PERMIT

TAX ID #04-321685
ON-SITE SEWAGE DISPOSAL SYSTEM
HOWARD COUNTY HEALTH DEPARTMENT
BUREAU OF ENVIRONMENTAL HEALTH

HOWARD COUNTY HEALTH DEPARTMENT

RE: **Variance Approval**
17006 Hardey Road
Mt. Airy, MD 21771

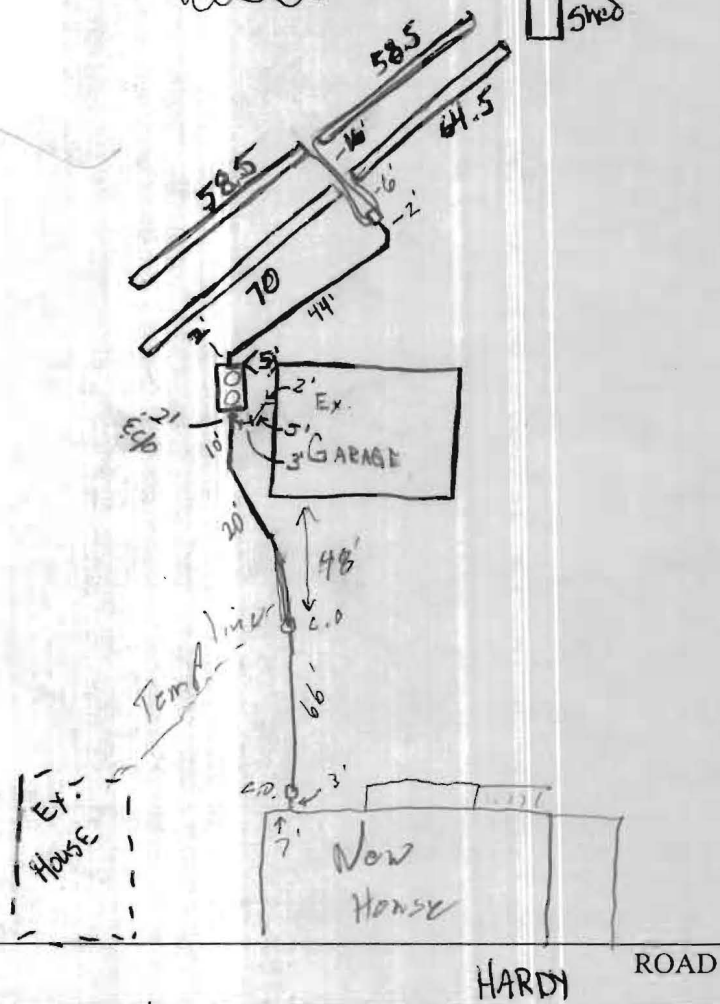
PRE-CONSTRUCTION 9/22/05 everything staked per approved plan (GAL)

11/??/05 Trenches installed per specs. OK to cover.

INSTALLATION 5/23/08 4" line from new house to S.T. complete
OK to cover Lot 4 green sticker (SO)

*pit well must be brought up to code (AT) 5/4/07

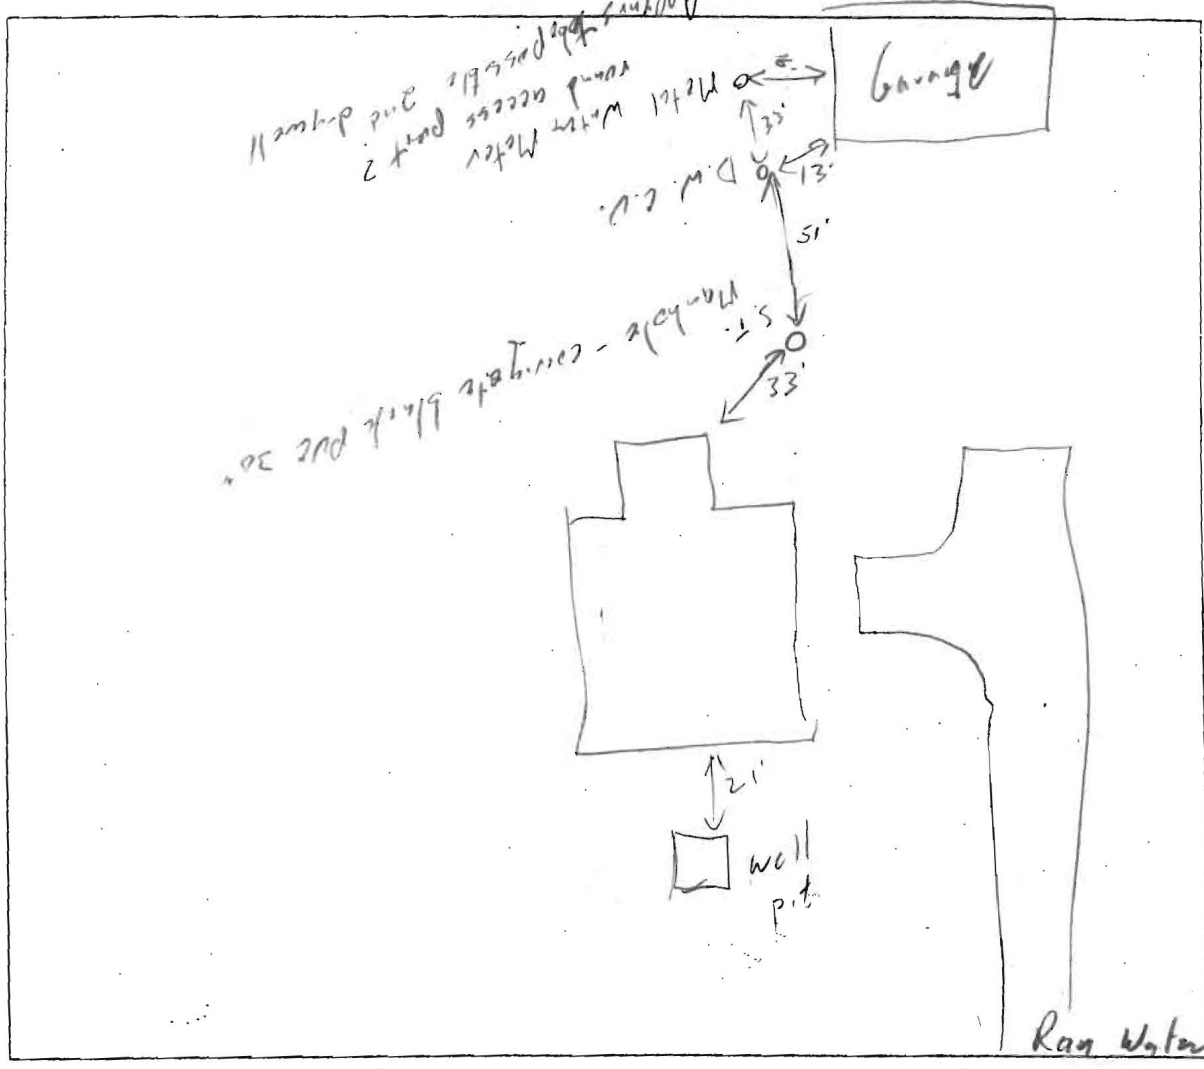
As per our conversation last week, we are requesting a waiver of the 100' setback requirement for propane tanks from well heads. This request is for the Sullivan residence on 17006 Hardy Road in Mt. Airy.

The reason for our request is the fact that the tank will be located approximately 92' from the well. If we move any further away from the well we will encroach on the septic area. If we move the tank beyond the septic area, the cost to the customer would be excessive.

I have attached a copy of the plat, which shows the tank and well locations. Please approve this waiver.

The Department of Health has received your variance request dated October 9, 2008 for the above referenced property and granted approval on October 20, 2008. On October 24, 2008 this agency received a second variance request. This agency will grant **approval** of the variance provided that the proposed new underground propane tank is constructed no closer to the well than the existing propane tank; eighty feet. Approval of a building permit will be granted by this Department provided that the site plan submitted with the building permit application is consistent with the site plan approved under this variance request. Any deviations from the site plan submitted with the request will be subject to further review by this Department.

The Department of Health has received your variance request dated October 9, 2008 for the above referenced property. This agency will grant **approval** of the variance provided that the proposed new underground propane tank is constructed no closer to the well than the existing propane tank; ninety-two feet. Approval of a building permit will be granted by this Department provided that the site plan submitted with the building permit application is consistent with the site plan approved under this variance request. Any deviations from the site plan submitted with the request will be subject to further review by this Department.
